To: Planning Commission
 City of Spring Lake Park

File: Variance Request
 8457 Sunset Road NE

From: Lauren Walburg,
 Stantec

Re: Bob Fearing – Variance, Side Yard Setbacks and Front Parking Setback, 8457 Sunset Road NE

Zoning Map

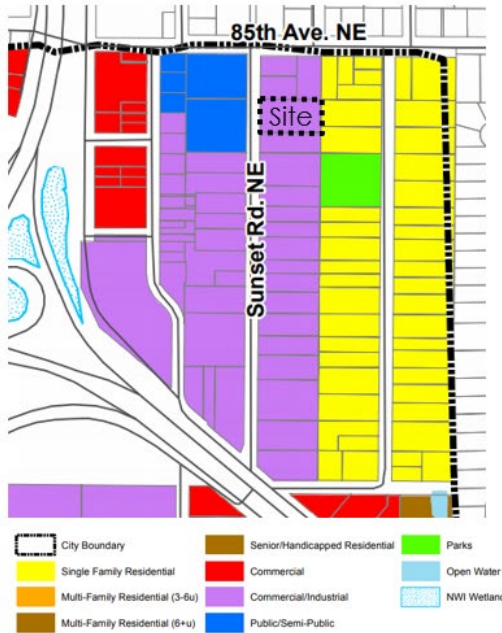
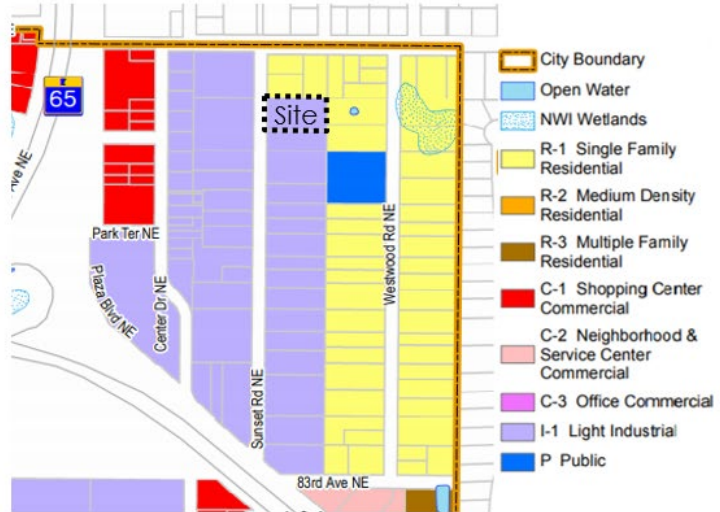
The land use and zoning pattern in the area is complex, but the request is simple (see map excerpts above):

- The site at 8457 Sunset Road NE is guided Commercial/Industrial and zoned I-1 Light Industrial.
- The Eagle Brook Church across Sunset Road NE is guided Public/Semi-Public but zoned I-1 Light Industrial.

- The homes to the north are guided Commercial/Industrial but zoned R-1 Single Family Residential.
- The homes to the east are guided and zoned Single Family Residential.

- In the Metropolitan Area, cities are obliged to have the zoning conform to the Land Use Plan. The Land Use Plan take precedence over the zoning.
- The single family homes north of the site could therefore be rezoned and redeveloped with Industrial uses at any time – the City would be obliged to rezone the property to I-1 to conform with the Land Use Plan.

- The request is for a variance to the side setback to the north that is the same as a future industrial use would require (if zoned according to the Land Use Plan) vs. what the existing residential uses require.

SITE PLAN

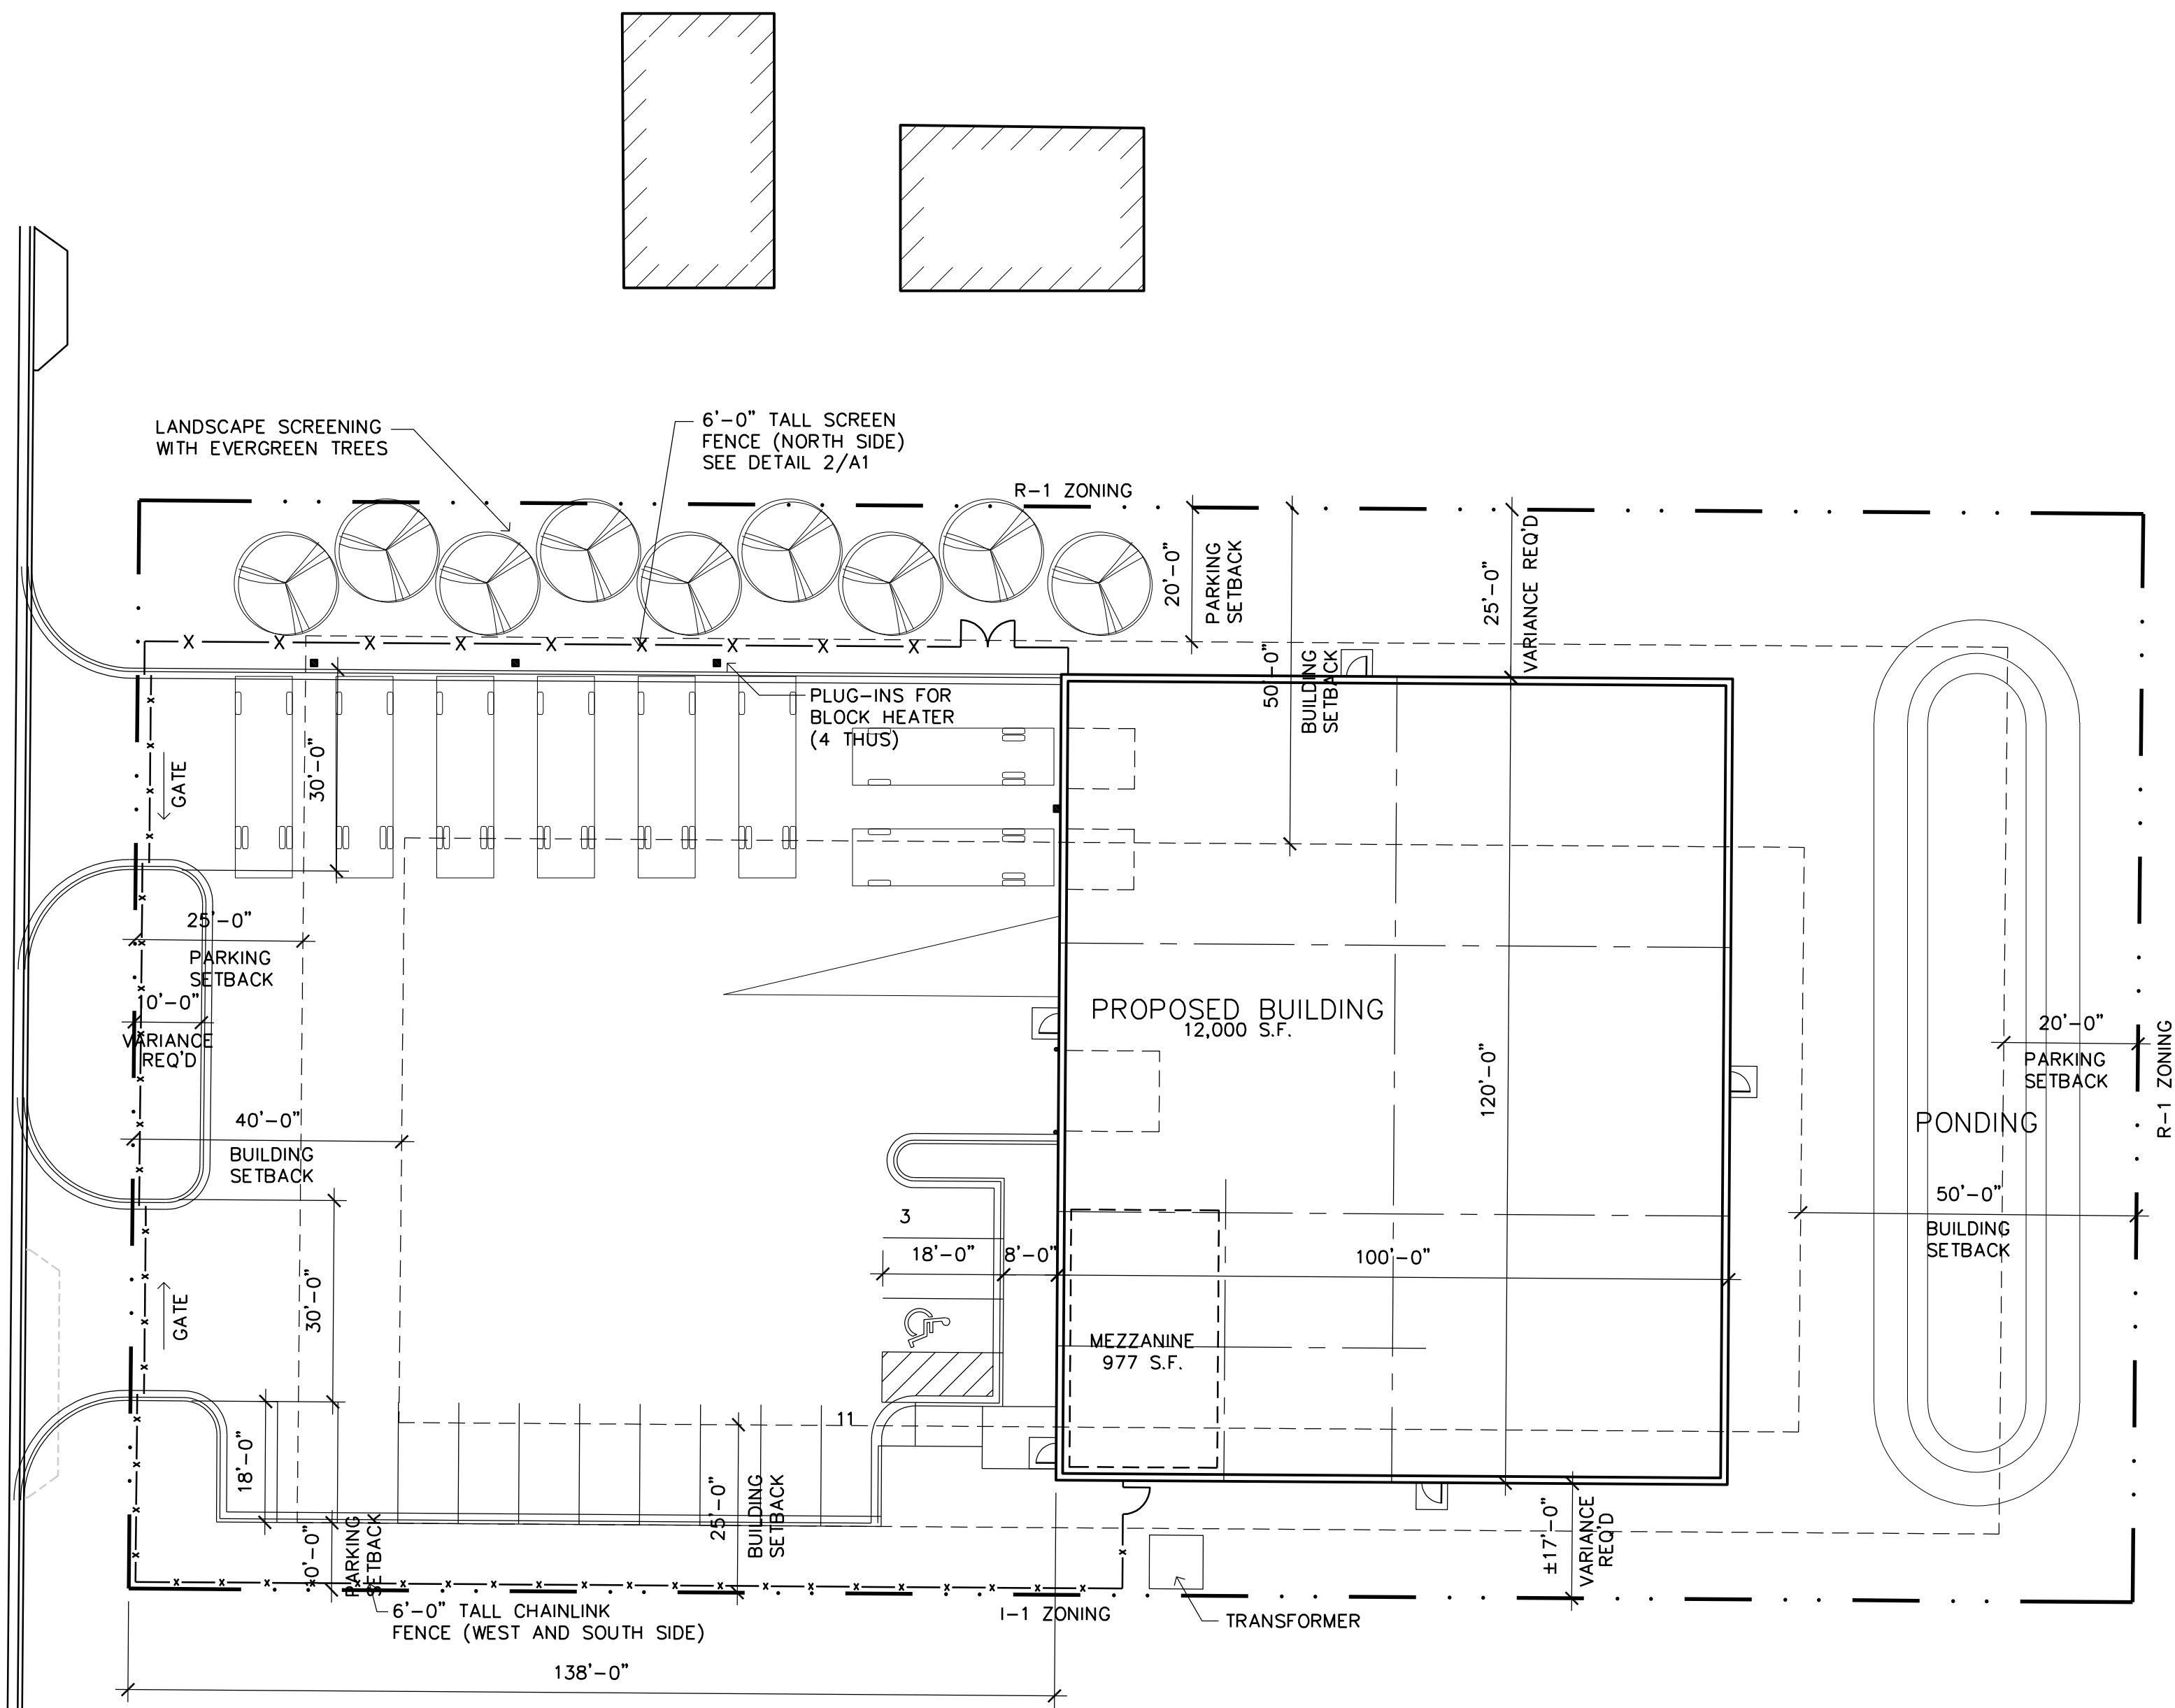
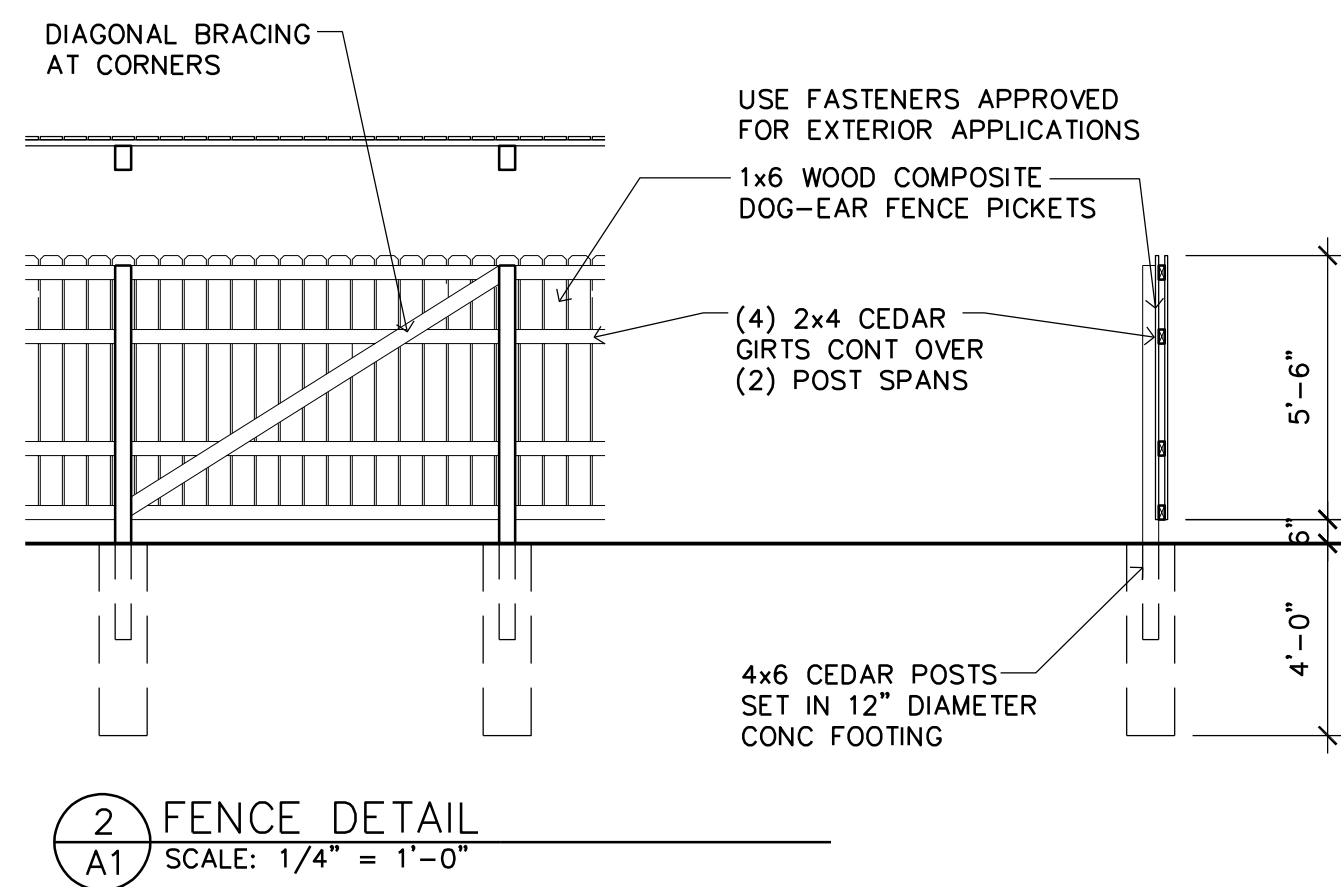
The previous variance request and the new variance requests are shown in the diagrams below. The yellow lines indicate variance requests (to either the required parking or building setback), and the red lines indicated the code required setback. The applicant is requesting to reduce the required 50 foot building side setback on the north (adjacent to residential) to a 25 foot setback. The applicant is also requesting a variance to the south side building setback from a required 25 feet to 17 feet. These setbacks will accommodate a rectangular building, with parking in front. Finally, the applicant is requesting a variance to reduce the required front parking setback from 25 feet to 10 feet to accommodate for their parking lot.

The site plan is laid out to have a sturdy 8 foot fence and landscaping facing north to the existing residences. Screening is required for all parking areas abutting residential uses per Zoning Code Section 153.138, but that will be handled in the Site Plan review process and no variance is requested for that here.

- 1) The side setback to the north is approved at 25 feet vs. the required 50 feet only if the main entrance to the building is not located on the north side and requested fence and landscaping is installed as indicated on the site plan.
- 2) Variances to the side setback to the south and parking setback in the front yard are approved only if the entire site is fenced for security.
- 3) Landscaping shall be provided in the north side yard as suggested on the site plan, with details to be reviewed and approved by the City Planner at the time of Site Plan review.
- 4) All other details of the proposed development will be reviewed in the Site Plan review process, including grading, drainage, stormwater management, landscaping and screening, signage, lighting, number of parking spaces, and other details as required by City Code.
